ALERT SERVICE BULLETIN

UH-1H-13-11
4 November 2013

SUBJECT: ASSIGNMENT OF A 3,300 HOUR RETIREMENT LIFE AND RE-IDENTIFICATION OF ELEVATOR ASSEMBLIES P/N 205-030-856-157 AND -159 INSTALLED ON THE UH-1H HELICOPTER

FIGURE 1

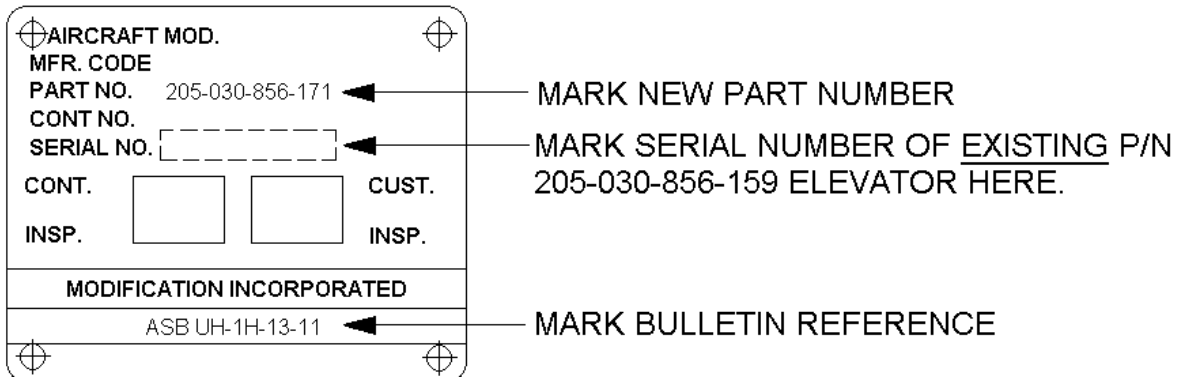
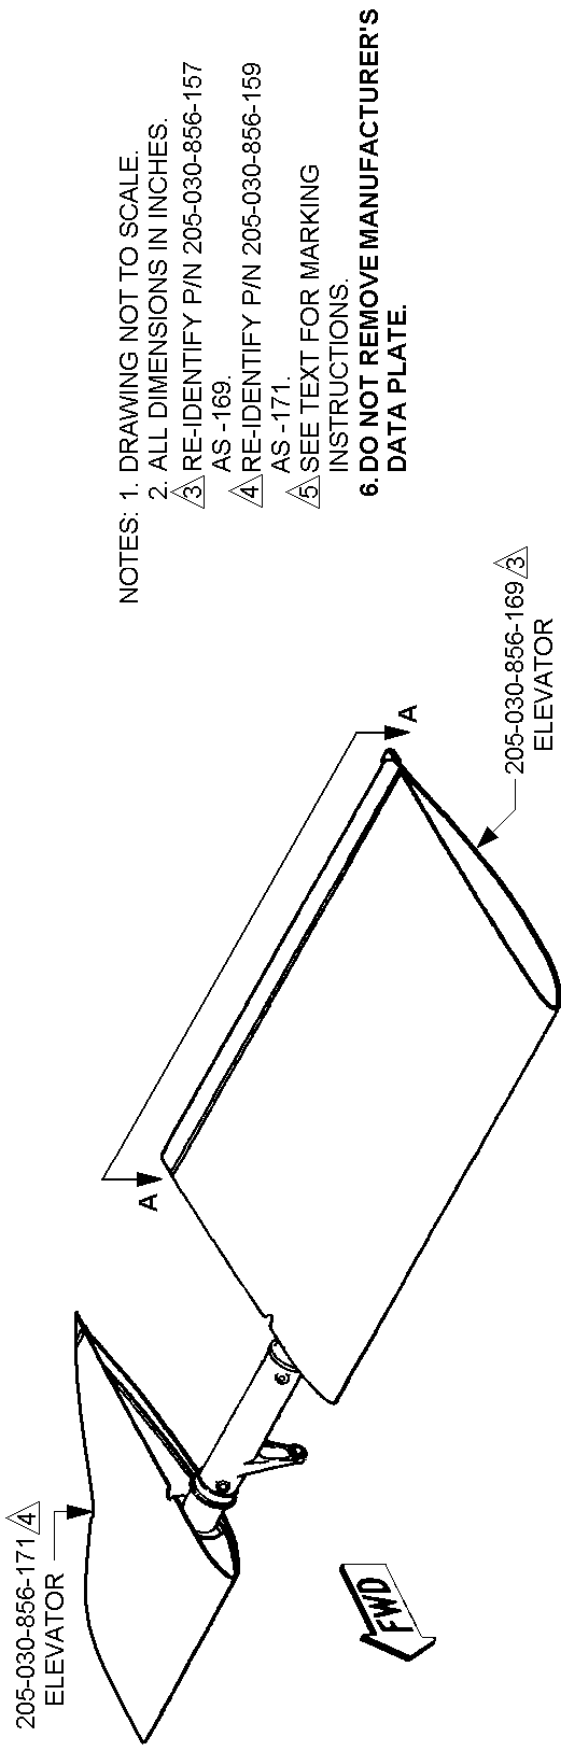
- a. Use a vibrating stylus, place a single scribed line through the entire existing part number on the manufacturer's data plate. **DO NOT OBLITERATE THE PART NUMBER AND DO NOT CHANGE OR ALTER THE SERIAL NUMBER.**
- b. Populate a P/N MS27253-1 modification plate as shown in Figure 1. Existing P/N 205-030-856-157/-159 elevator serial numbers shall not be changed or altered.
- c. Install the modification plate on the appropriate elevator assembly as shown in Figure 2. **Do not remove the existing manufacturer's data plate.**

NOTE: MARK MS27253-1 MODIFICATION PLATE USING IMPRESSION STAMP, DOT PEEN, OR VIBROSCRIBE ONLY.

FOR P/N 205-030-856-157 ELEVATORS

FOR P/N 205-030-856-159 ELEVATORS

FIGURE 2

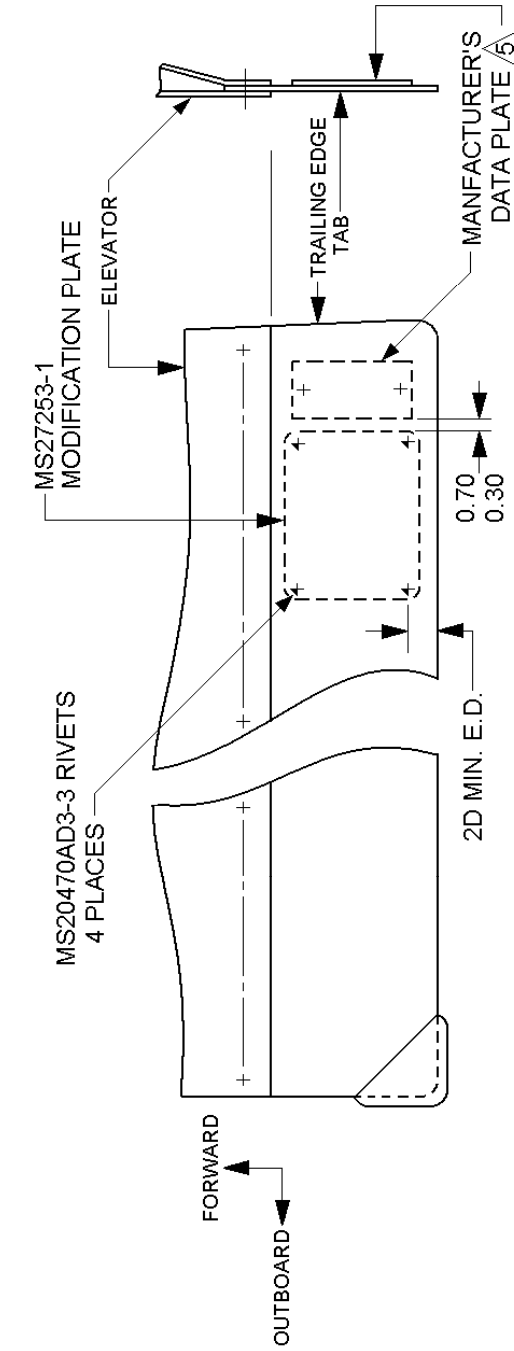
- 1) Locate the modification plate and back drill four fastener holes in the elevator tab. Use care to not bend the tab.
 - 2) Remove the modification plate and deburr holes in the elevator tab.
 - 3) Install each modification plate with four (4) MS20470AD3-3 rivets. Install fasteners with wet primer. Remove excess primer.
 - 4) Touch up primer and paint on the elevator tab as required.
- d. For each elevator modified, create a new historical record card (HRC) using:
- (1) The new part number, original elevator assembly serial number from the manufacturer's data plate, elevator total flight hours from the original HRC, and indicate the retirement life as 3,300 hours.
 - (2) Note elevator has been modified in accordance with this ASB.
 - (3) Update all other helicopter records as required.

- NOTES: 1. DRAWING NOT TO SCALE.
 2. ALL DIMENSIONS IN INCHES.
 3. RE-IDENTIFY P/N 205-030-856-157 AS -169.
 4. RE-IDENTIFY P/N 205-030-856-159 AS -171.
 5. SEE TEXT FOR MARKING INSTRUCTIONS.
 6. DO NOT REMOVE MANUFACTURER'S DATA PLATE.
